Project No. 2021\_154

MIDLOTHIAN ISD STADIUM ADDITIONS AND RENOVATIONS

ADDENDUM NO. 2

DATE: October 18, 2021

AD101

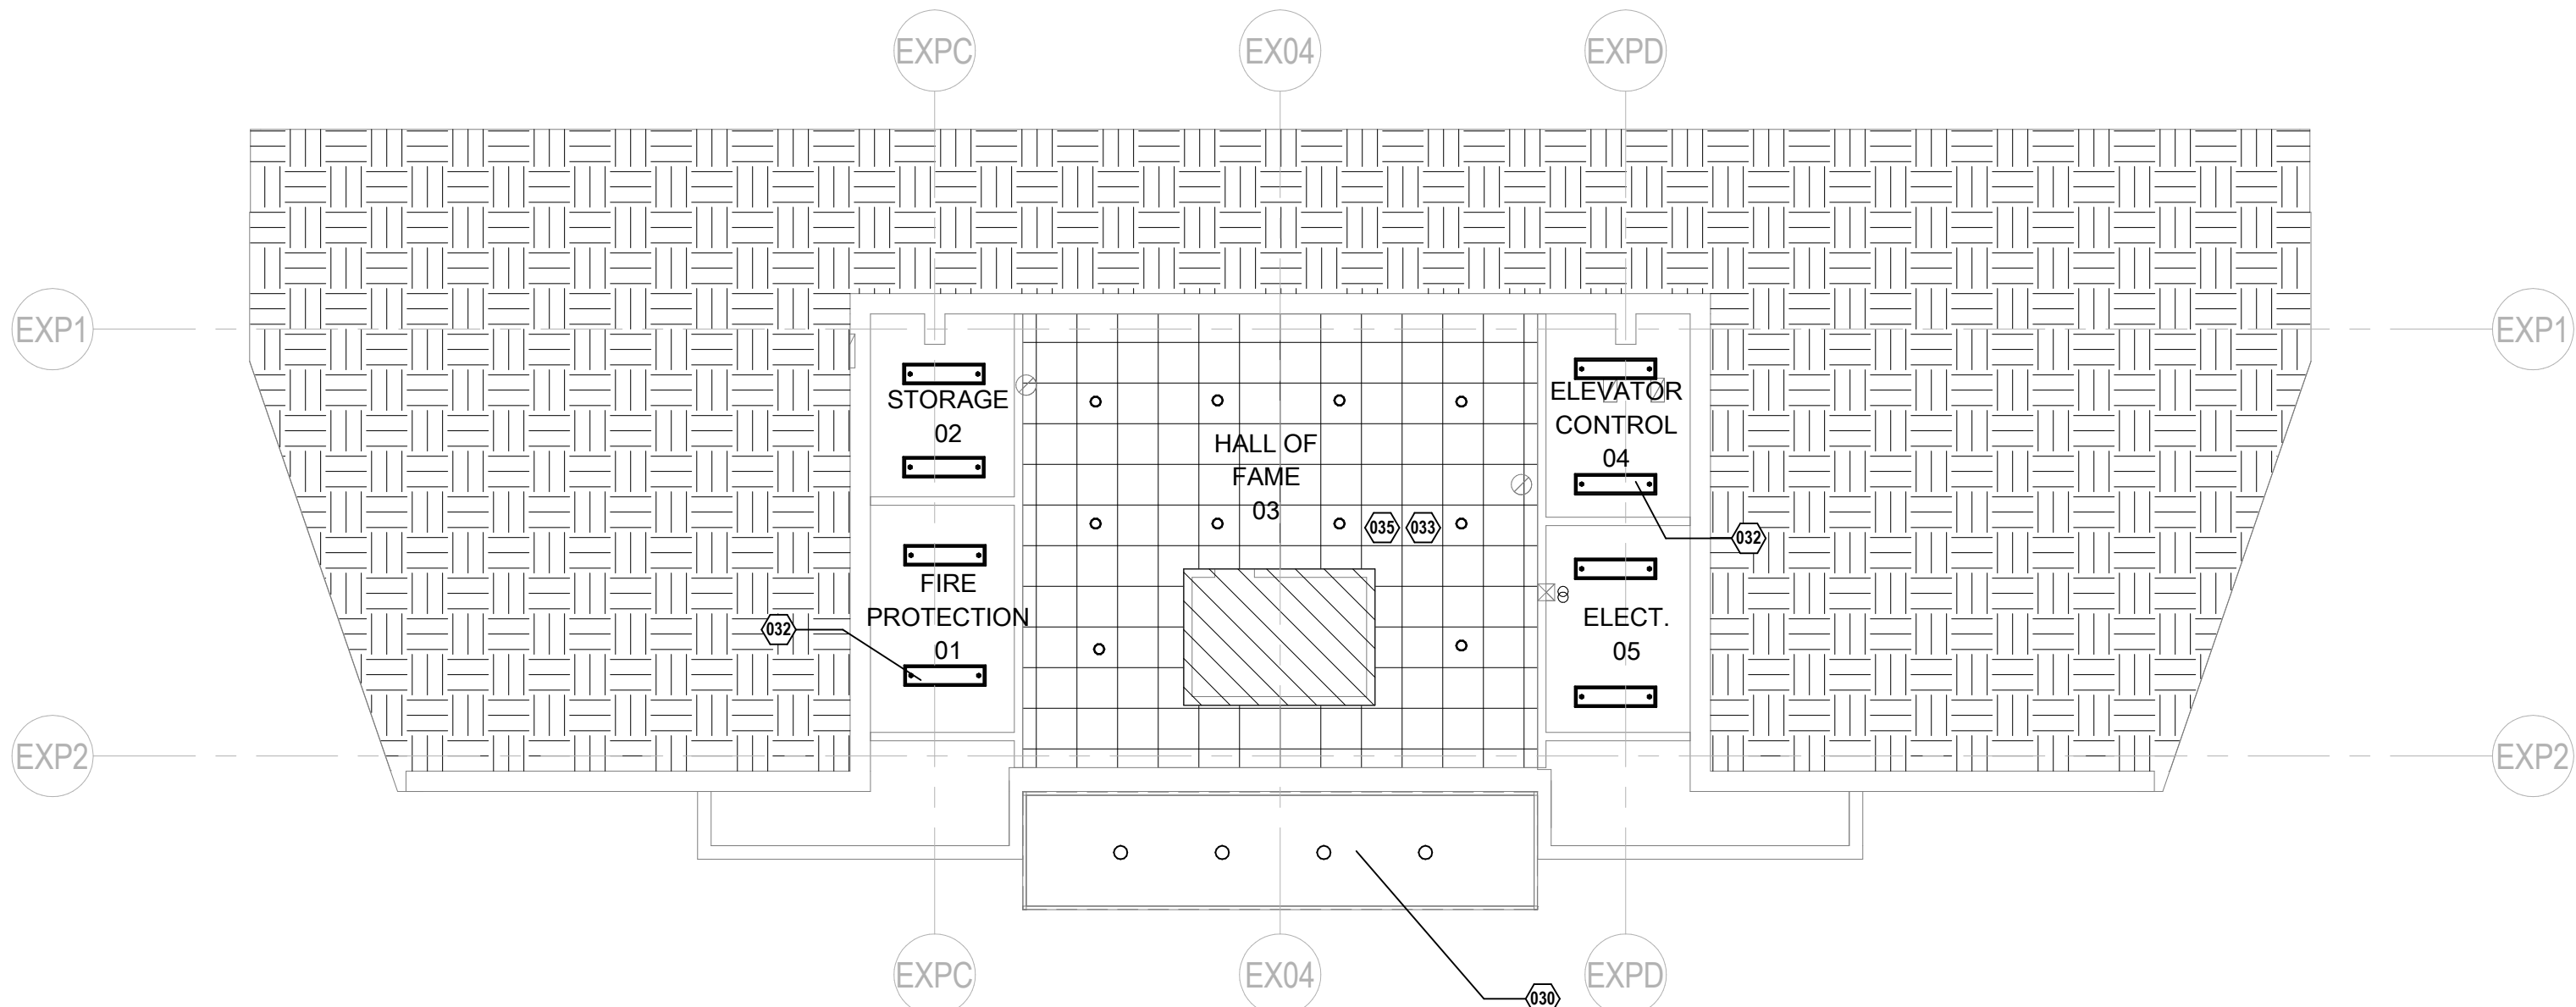
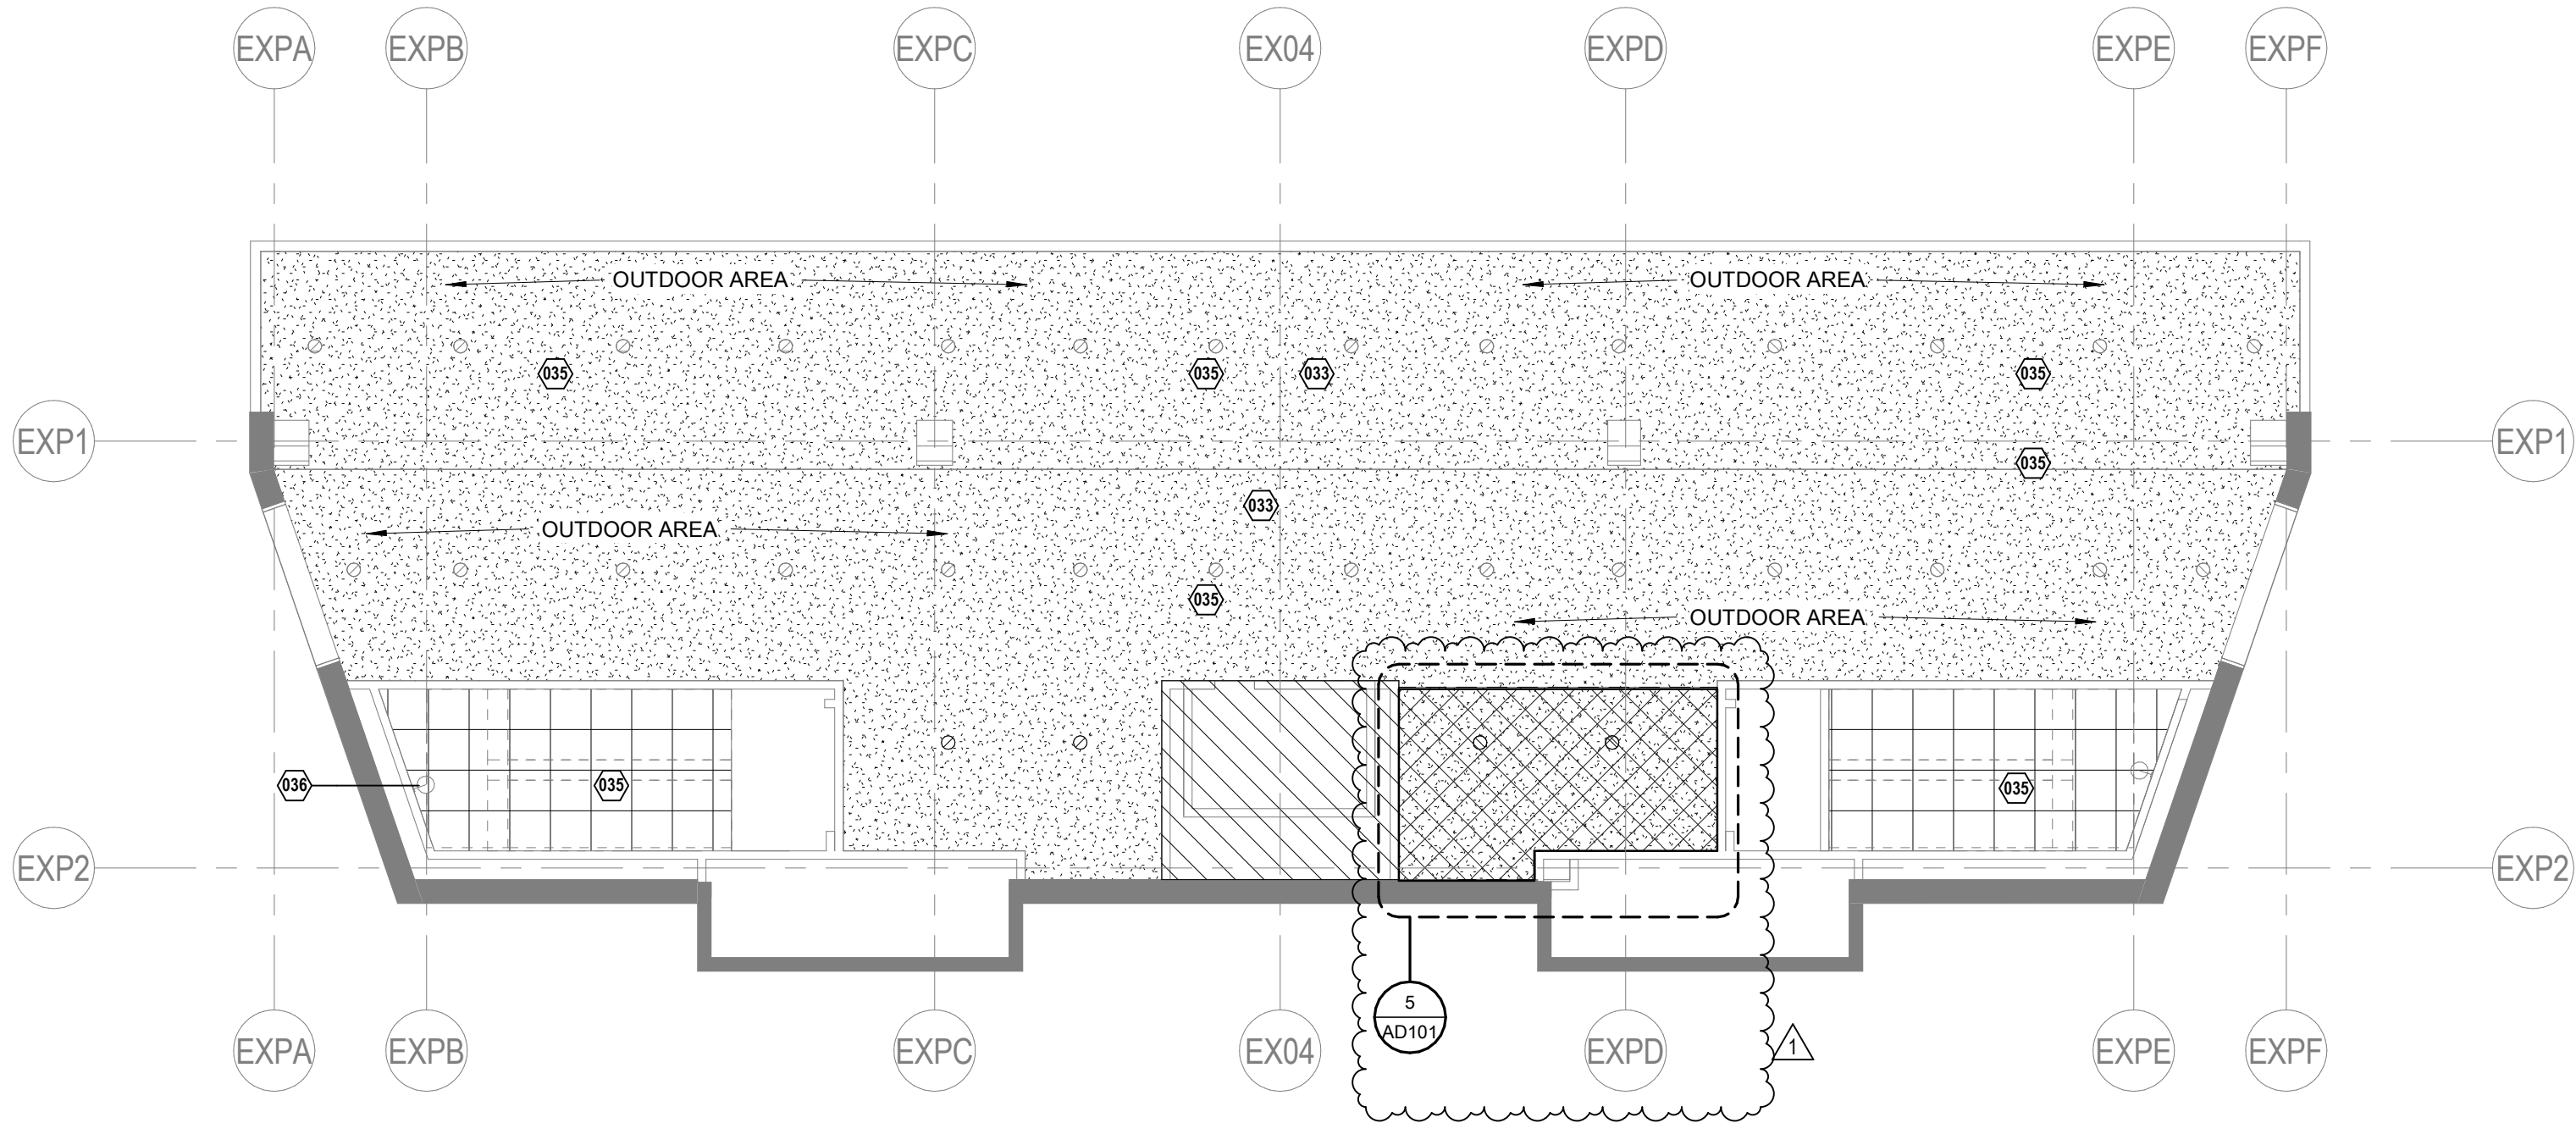
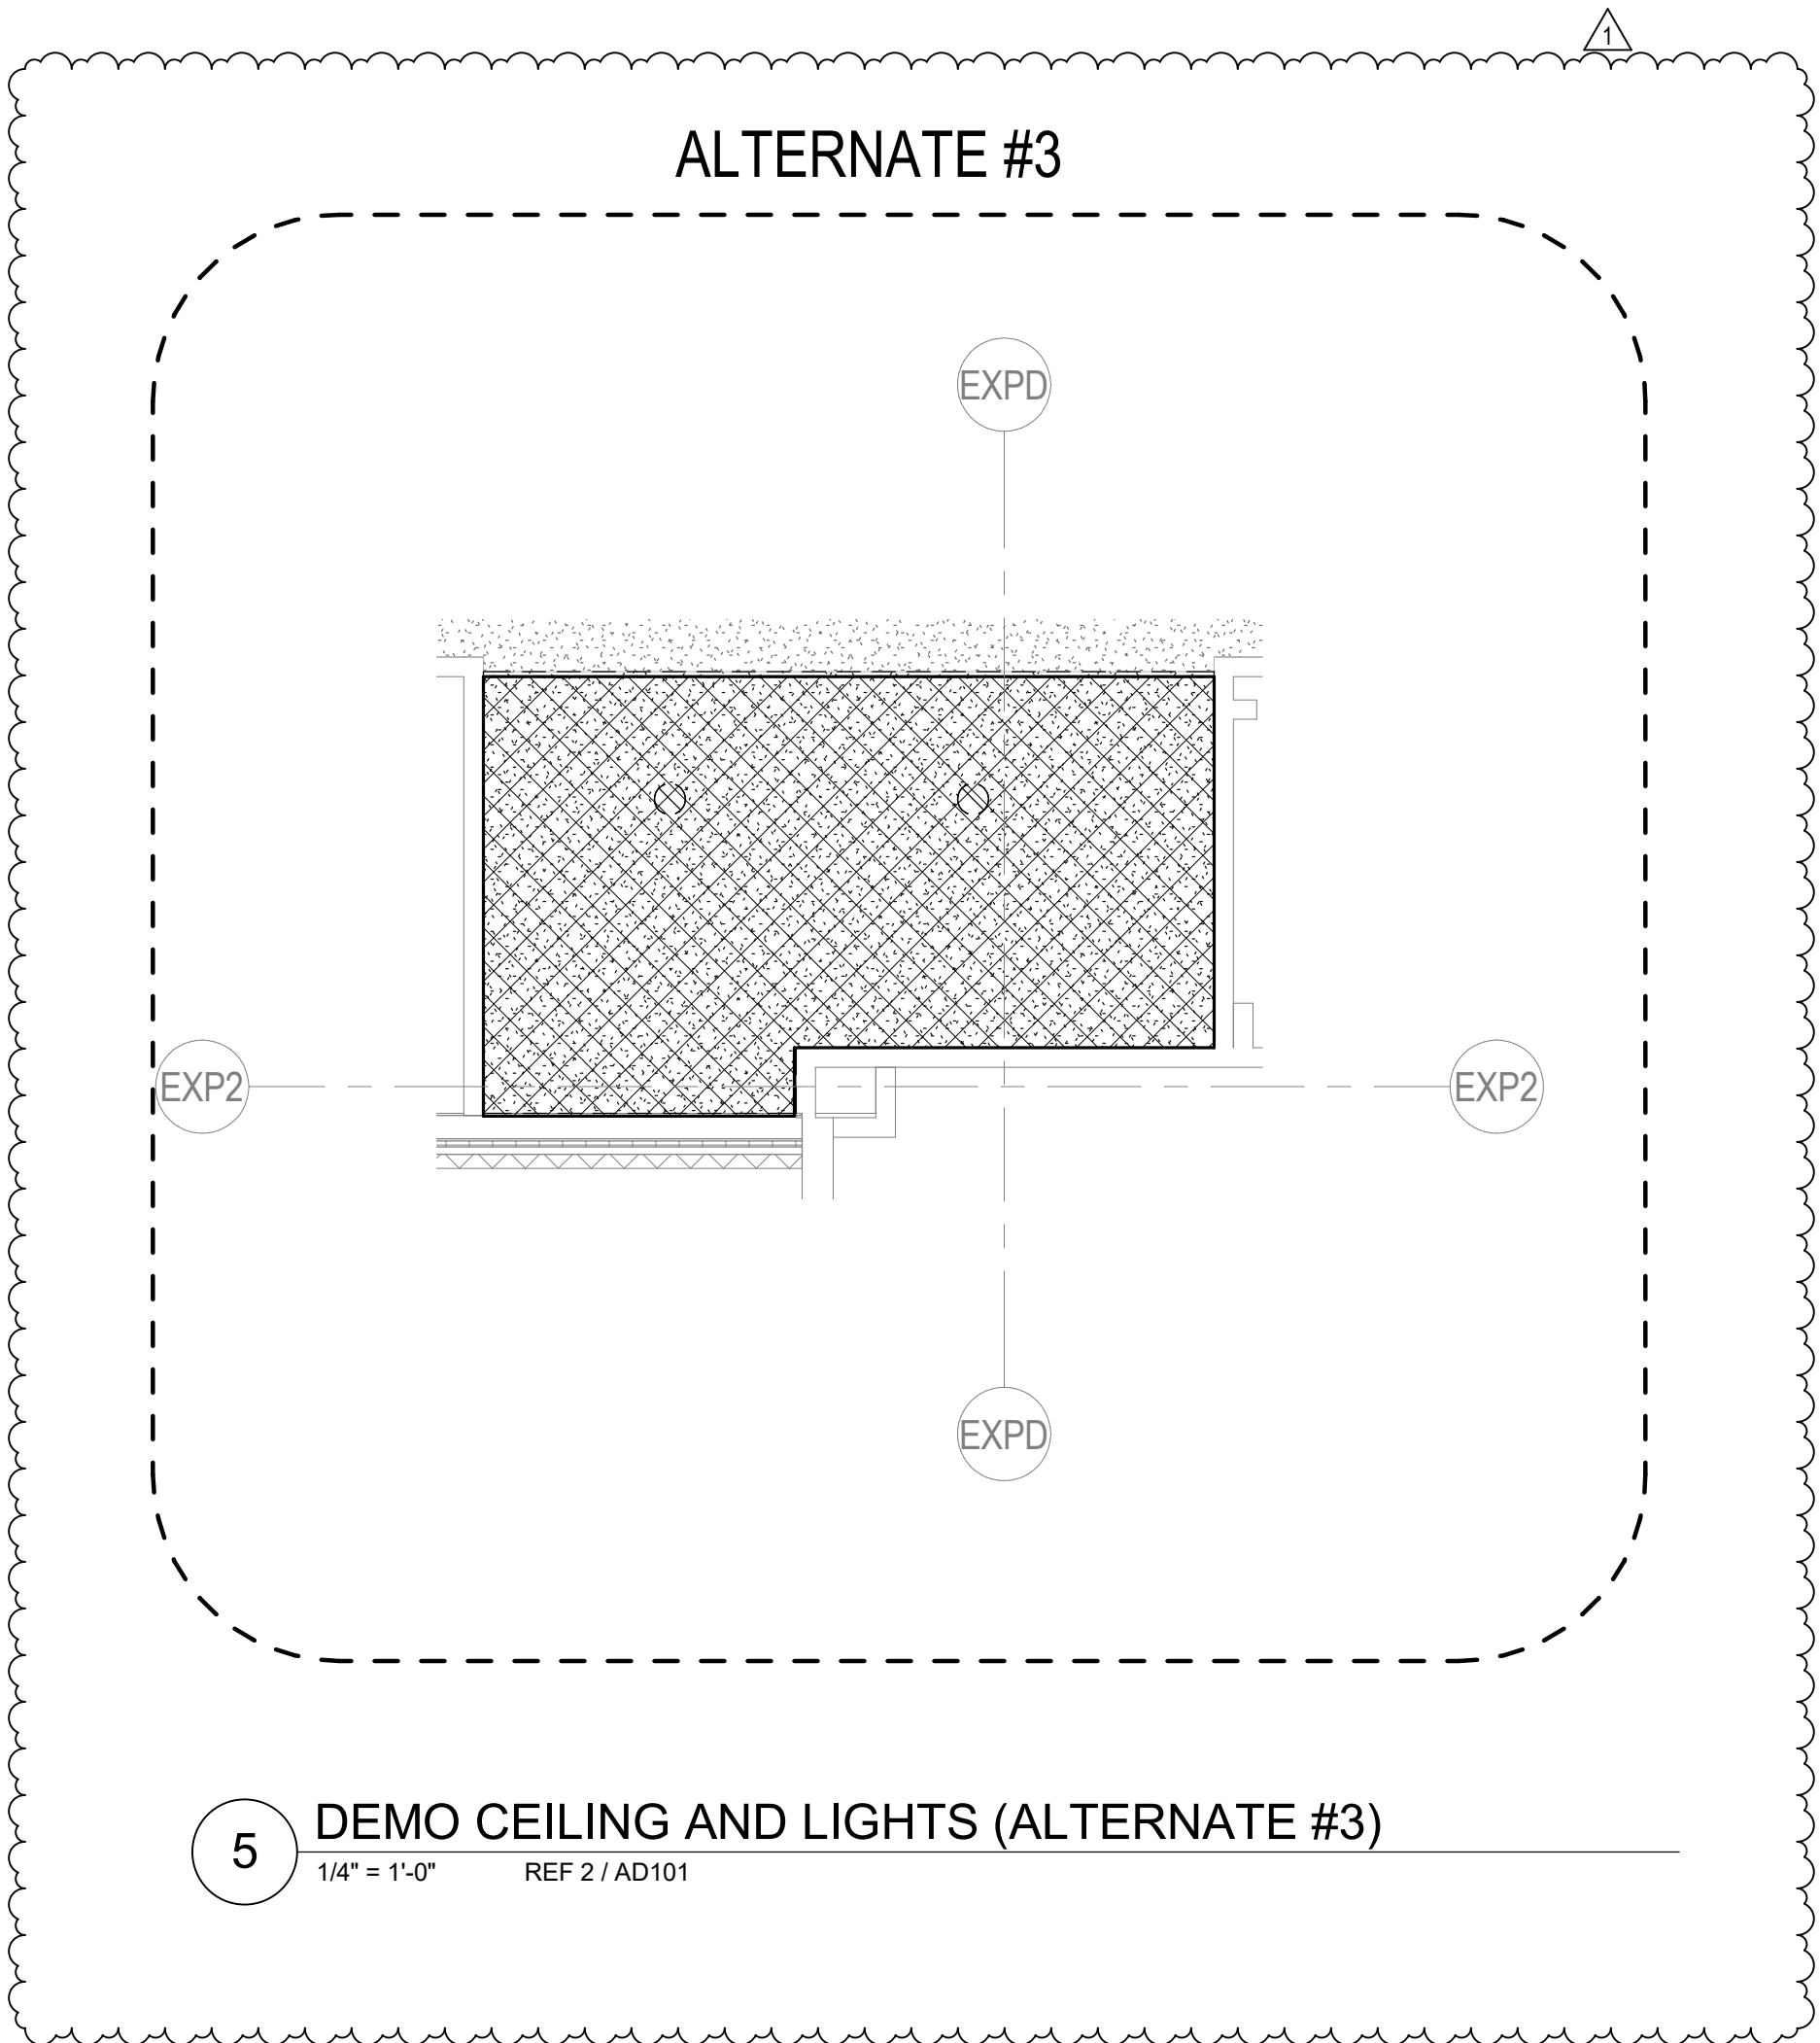
- A2.6 SHEET AD-101 – DEMOLITION CEILING PLAN:  
REMOVE and REPLACE in its entirety.  
a. Control Room 120 MOVED its location, so our demo MOVED as well to the other side of existing elevator.
